Anonymous Referee #1

Comments from Referee 1:

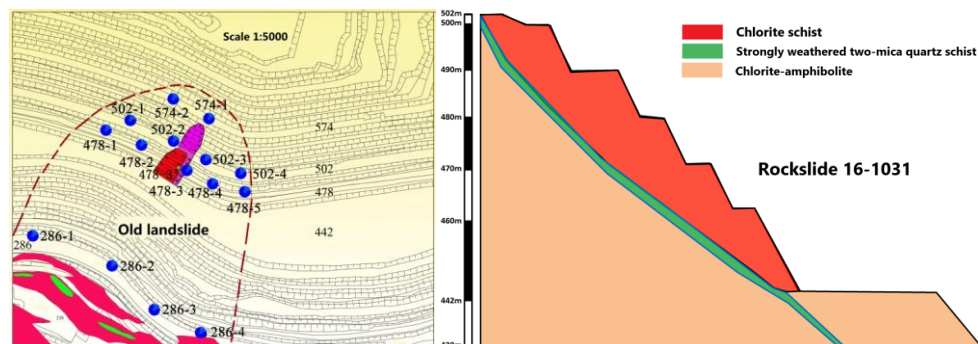
Dear Editor and Authors, This paper addresses the issue of monitoring of rocky slope instability and failure analysis using the FEMLIP method, and the normalized global second order work as failure index. The paper is innovative in terms of methods and tools and provides useful results for the efficiency of the monitoring and the numerical analysis of rock slides, as tools for the prediction and simulation of failure and the early warning. The methods used and the results are clearly explained. Figures are sufficient, although the quality can be improved (please check comments on the pdf file for Figure 2b).

Thanks so much for your pertinent comments. The 2 figures you pointed out had been substituted, and the resolution had been improved.

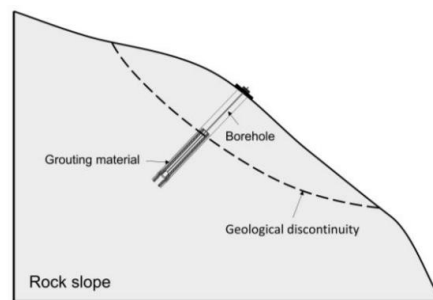
The monitoring method is interesting, and the comparison between the monitoring data and the numerical result, the global second order work, is a good attempt. I just wonder how the CRLD cable is installed in the borehole, how it is anchored?

Thanks for your kindly comments. Regarding the installation of the CRLD, the borehole is drilled through the geological discontinuity as shown in the figure as follows. The sleeve pipe is anchored in the borehole by the grouting material generally with a thickness of 14.5 mm, and one end of the stands is fixed on the slope surface.
